**AMERICAN BADGER MITIGATION AND
HABITAT RESTORATION PLAN
FOR THE
TRANS MOUNTAIN PIPELINE ULC
TRANS MOUNTAIN EXPANSION PROJECT
NEB CONDITION 44**

July 2017

REV 2

01-13283-GG-0000-CHE-RPT-0024 R2

Figure 1 Retention and Replacement of Biophysical Features/Attributes of Critical Habitat for American Badger^{1,2}

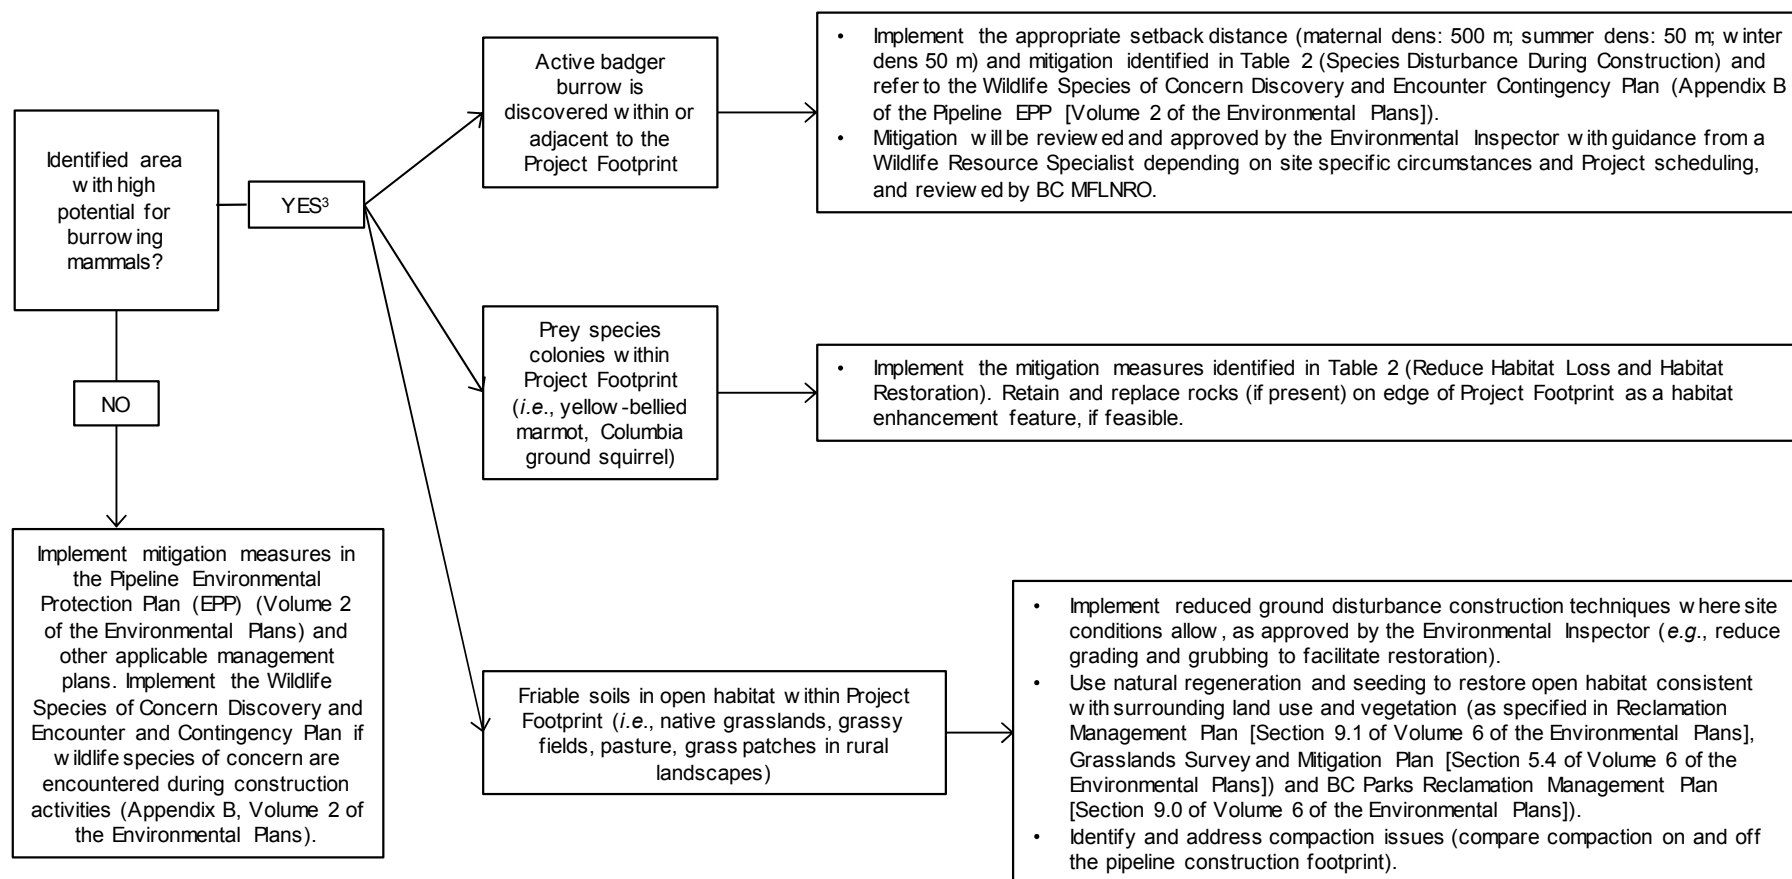
BC MFLNRO – Okanagan Region, Ecosystems	Email	February 1, 2017	<u>Section 5.3: Mitigation and Habitat Restoration Measures</u> Table 3 (now Table 2): Habitat Restoration - There is a plan for marmots but why was there no corresponding plan for Columbian ground squirrels?	Marmot burrows are often associated with cover objects such as coarse woody debris and rock piles. A habitat restoration/enhancement measure was therefore specifically included. Columbian ground squirrels are associated with open habitat and soils suitable for digging. The mitigation measures for American badger (soil handling, decompaction, restoration, seasonal timing) in Section 5.3 (Table 2) also serve to mitigate Project effects for Columbian ground squirrels.	Section 5.3 (Table 2).
BC MFLNRO – Okanagan Region, Ecosystems	Email	February 1, 2017	<u>Section 5.3: Mitigation and Habitat Restoration Measures</u> Figure 1: The figure notes that "Mitigation will be reviewed and approved by the Environmental Inspector with guidance from a Wildlife Resource Specialist." for when an active badger burrow or prey colony is found. However, relevant mitigation measures should be included in this plan before construction begins and relates to several comments already from Table 3 [now Table 2] in Section 5.3.	Additional information has been added to Table 2 to provide greater clarity on the actions to be implemented.	Section 5.3 (Figure 1)
